SUPPLEMENTARY REPORT

GEOTECHNICAL INVESTIGATION

SALINE RIVER BRIDGE - MILE 521.0
AND LITTLE SMITH CREEK BRIDGE - MILE 533.0
MACKENZIE HIGHWAY

SUPPLEMENTARY REPORT
FOUNDATION INVESTIGATIONS
PROPOSED BRIDGES

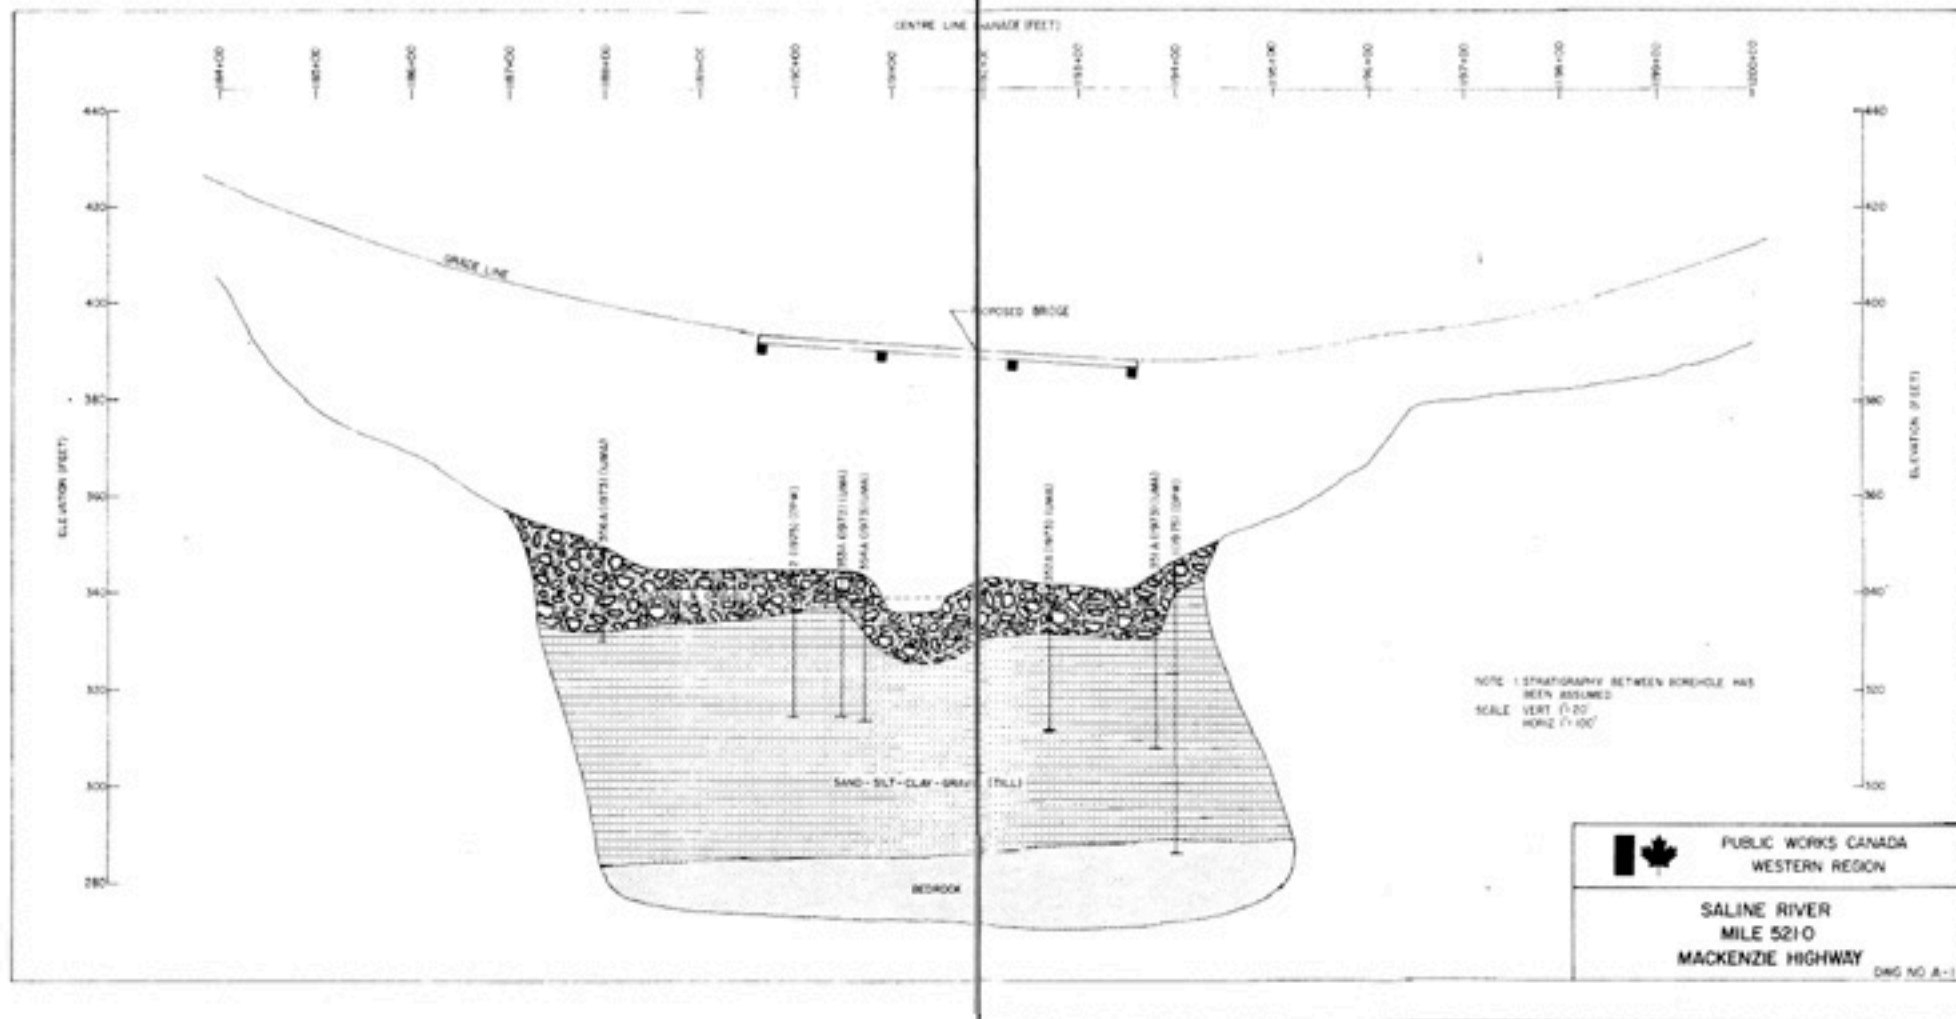
With reference to Drawing No. A-1 in Appendix A, the 1975 boreholes confirm the subsoil stratigraphy as inferred from the 1973 boreholes. (Note - several of the 1973 holes by UMA were upstream of the crossing site)

Hole #1 (1975) near the south abutment was extended to a depth of 60' where bedrock (shale) was encountered. Hole #2 (1975) near the north abutment was terminated at a depth of 30 feet in the dense glacial till. Permafrost was reported in hole #1 to a depth of 18' - none of the holes by UMA reported permafrost.

range of 80 tons. This is considered slightly optimistic, especially for steel H-piles, and it is recommended the piles be designed on the basis of an allowable unit adhesion value of 450 p.s.f. in the till (vs. 600 psf. by U.M.A.), plus an allowable end-bearing of 15 kips per square foot.

The pile section used should be moderately heavy to ensure penetration of the upper granular deposits - 12BP53 H-piles or 10.75" pipe piles @ 40 lbs./ft. may be employed. The pile hammer should have a ram at least as heavy as the piling in order to impart relatively high energy - low velocity blows to the piling - an energy of roughly 20,000 ft. lbs. per blow is recommended.

LITTLE SMITH CREEK
MILE 533.0
MACKENZIE HIGHWAY

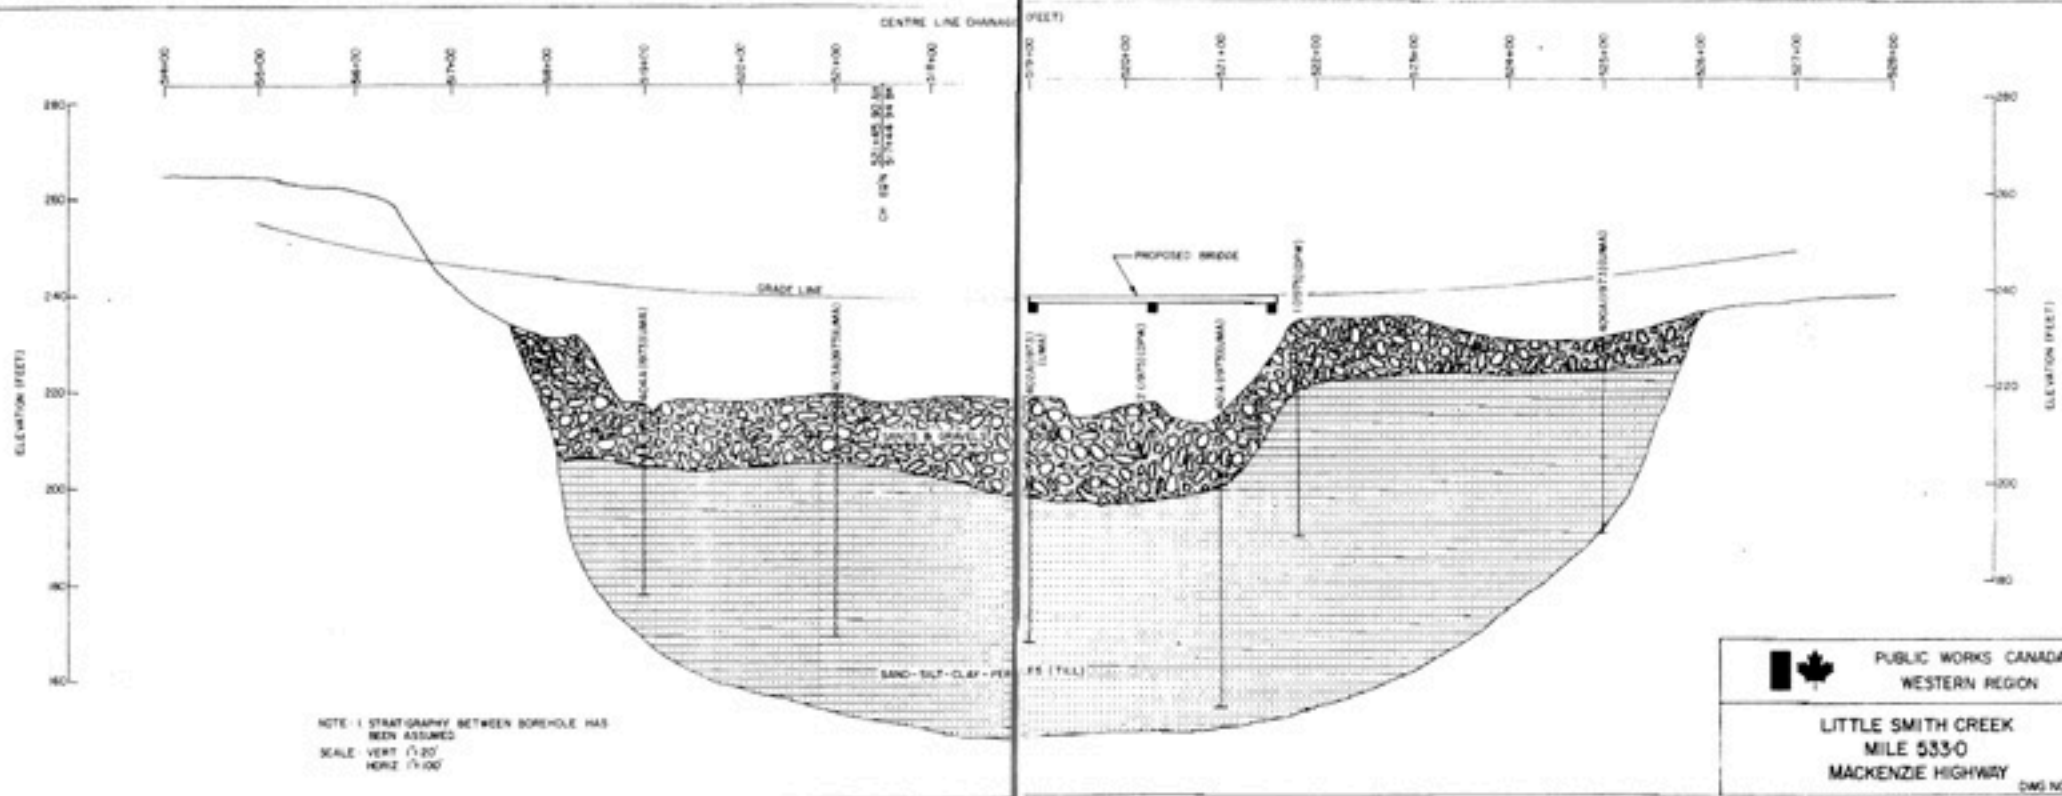
With reference to Drawing No. B-1 in Appendix B, the 1975 boreholes confirm the subsoil stratigraphy as inferred from the 1973 boreholes. However there may be some discrepancy regarding the presence of permafrost.

None of the holes by U.M.A. within the present channel, or on the adjacent flood plain, reported permafrost. However hole #1 by D.P.W. on the south channel bank, and 25'-30' south of the proposed abutment location, indicated frozen ground to the drilling depth of 43'. It is entirely possible that there is a thaw zone only below the channel, as investigations at several stream crossings in permafrost terrain have revealed such limited thaw areas which are confined directly below the width of flow. Thus it is possible that Holes 401A, 402A, 403A and 404A (UMA) within the channel were in a thaw zone, and Hole #1 (DPW) on the channel bank was in permafrost. However it is believed that there is permafrost in the area of Hole 400A (400' south of the channel), although none was reported by U.M.A. Permafrost was encountered throughout the south valley wall and adjacent to the stream channel by D.P.W. thus it is considered likely permafrost is present below the floodplain in the area of Hole 400A.

Underwood, McLellan have recommended an allowable adhesion value of 600 p.s.f. for steel piling, but have also estimated a pile penetration of 30 to 40 feet to refusal in unfrozen till

Underwood, McLellan & Associates have recommended steel piling and this is concurred with. Open-ended steel pipe piles are considered the most practical for this site due to the presence of cobbles and boulders in the upper granular stratum, and to the possibility of encountering permafrost near the south abutment.

A heavy section - at least 10" diameter @ 40 lbs./ft., should be used to withstand hard driving which may be required to penetrate the granular stratum, and to gain adequate penetration into the till if permafrost should be encountered. The hammer used should have a ram at least as heavy as the piling in order to impart relatively high energy - low velocity blows to the piling - an energy of roughly 20,000 ft. lbs. per blow is recommended.

below existing grade, wherein the allowable pile load could be based upon the structural column strength. Since the possibility of some permafrost does exist at this site, and 'false' or 'short-term' refusal may result in the frozen ground, it is recommended the pile loadings and lengths be based only upon pile adhesion. The adhesion value of 600 p.s.f. recommended by U.M.A. is considered slightly high for an average value over the length of a straight sided pile in the very stiff till, as the effects of driving may create an annulus around the pile and the stiff till will not 'flow back' around the pile. Thus an average value of 450 p.s.f. is recommended. Should permafrost be encountered (and confirmed) during driving and it becomes practically impossible to conventionally drive the piles to the design penetration, then the piles may be advanced by a combination of pre-drilling a lead hole 1/2 to 1" in diameter less than the pile and driving, and/or drilling ahead of the pile through the central core. Pile installation should be under close inspection and driving trials may be required to ensure that pre-drilling does not exceed acceptable limits and pile bearing is effected. As an initial requirement it is recommended the lead hole be limited to 75% of the design pile penetration.
